MODEL
2.5TL
3.2TL

VIN APPLICATION
ALL with
ACCESSORY
MOONROOF VISOR

BULLETIN NO.
96-037

Wind Noise From the Moonroof

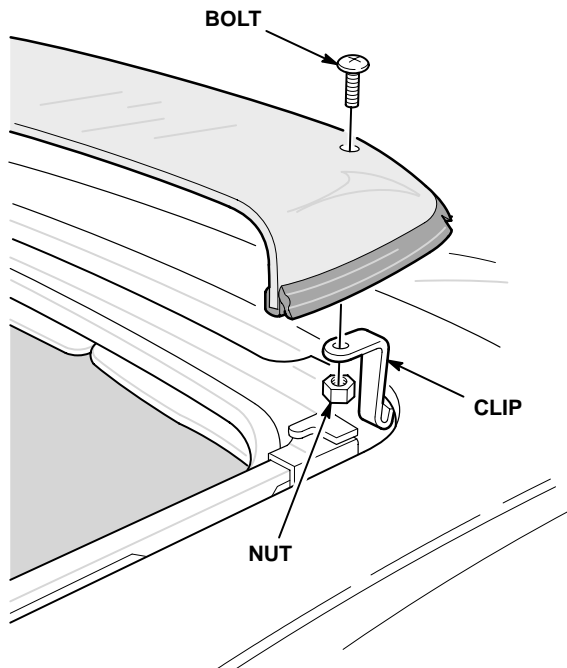
With the moonroof closed, a whistling noise comes from that area at highway speeds.

The mounting clips do not clamp the accessory moonroof visor tightly, allowing it to lift at highway speeds.

Replace the moonroof visor clips and mounting hardware with the new parts in the kit listed under PARTS INFORMATION.

Moonroof Visor Clip Kit: P/N 08R01-SW5-200R1
